UNITED STATES PATENT AND TRADEMARK OFFICE

Office Action Summary	Application No.	Applicant(s)
	10/597,831	DE MARTIIS, GIANCARLO
	Examiner	Art Unit
	MAI T. NGUYEN	3671

DETAILED ACTION

Regarding claim 16, Vinas Peya discloses a tooth in Figs. 1-13 and Figs. 1A and 4A below, comprising:

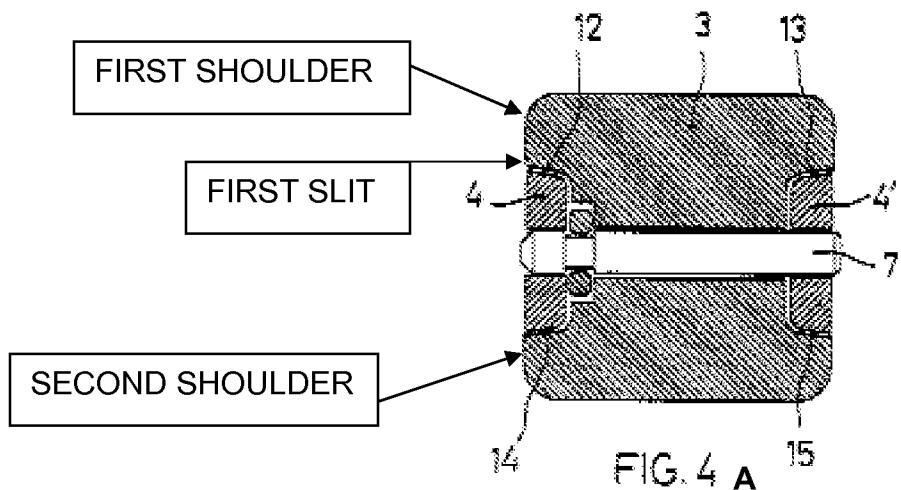
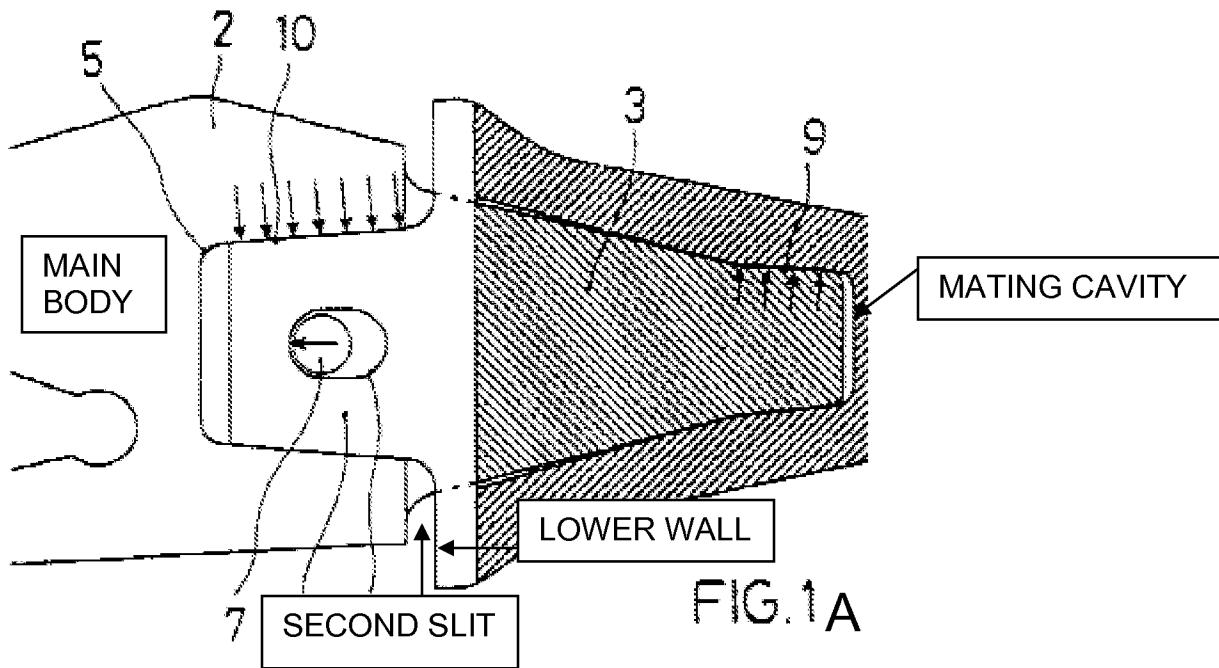
a fin 4, 4', 28, 29 protruding from a rear of the work element and configured to be received by a mating recess 5, 34, 35 disposed in the main body of the support element, the fin being disposed between first and second shoulders (unnumbered) of the working element and having an upper profile (unnumbered) disposed at an angle to the first shoulder and within the mating recess when the tooth is in the coupling condition, see Fig. 4 ;

Regarding claim 4, Vinas Peya discloses the cavity is delimited at a lower part by a lower wall (unnumbered), wherein a second slit is between a lower segment of the main body and the lower wall, see Fig. 1A, and a width greater than the first slit.
